Z-32 CENTRAL GARDEN EAST LOS TRAD LOT 646, ITH DISTRICT, 2nd SECTION COBS COUNTY, GEORGIA (2014) ZONING PLAN ma usu-sam me + Z 24 YOM CONTACT. PORT OF CONTACTOR PATTS I RECEIVE TRANS IND BELLS TRANS CAD SAMETTA ON SCORE © # PM 4:27 0 0 0 0 COURT OF SECTION CO. CARD.

APPLICANT: Patrick Malloy Companies, LLC	PETITION NO:	Z-32
(770) 319-5258	HEARING DATE (PC):	06-03-14
REPRESENTATIVE: Garvis L. Sams, Jr. (770) 422-7016	HEARING DATE (BOC): _	06-17-14
Sams, Larkin, Huff & Balli	PRESENT ZONING:	RA-5, R-20
TITLEHOLDER: <u>Dabney Partners, LLC, Cooper Lake Holdings, LLC,</u>		
George M. Hardage, Rosemary N. Hardage, Estate of Inez Glass	PROPOSED ZONING:	RA-5
PROPERTY LOCATION: South side of Lee Road, north side of		
Cooper Lake Drive, west of Atlanta Road.	PROPOSED USE: Single-F	amily Residential
ACCESS TO PROPERTY: Cooper Lake Drive	SIZE OF TRACT:	5.4 acres
	DISTRICT:	17
PHYSICAL CHARACTERISTICS TO SITE: Existing houses	LAND LOT(S):	696, 745
	PARCEL(S): 23, 24, 27	7, 28, <i>36,112</i>
	TAXES: PAID X DU	JE
CONTIGUOUS ZONING/DEVELOPMENT	COMMISSION DISTRICT	:_2

APPLICANT: Patrick Malloy Companies, LLC	PETITION NO.:	Z-32
PRESENT ZONING: RA-5, R-20	PETITION FOR:	RA-5
**********	******	*****

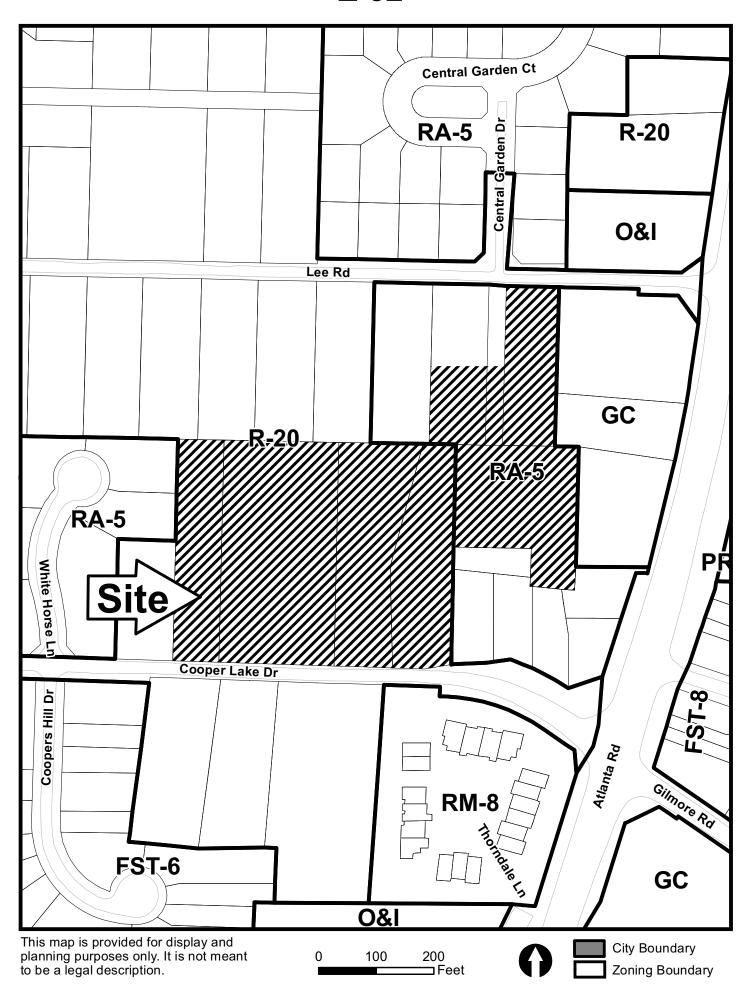
THERE APPEARS TO BE LITTLY EARDERST SCHOOL TO THE SETT AT THE PROCESSAN TO SETTING THE COOPER LAKE DRIV Salar Salar (60) ANTE E PROPERE DE CITE EN PARTE DE PARTICIONES DE CONTROL PARTICIONES PER PROPERE DE LA PROPE DEL LA PROPE DE LA PROPE DEL LA PORTICIA DEL LA PROPE DELA 0 0 TEMA FLOOD MAP VICINITY MAP
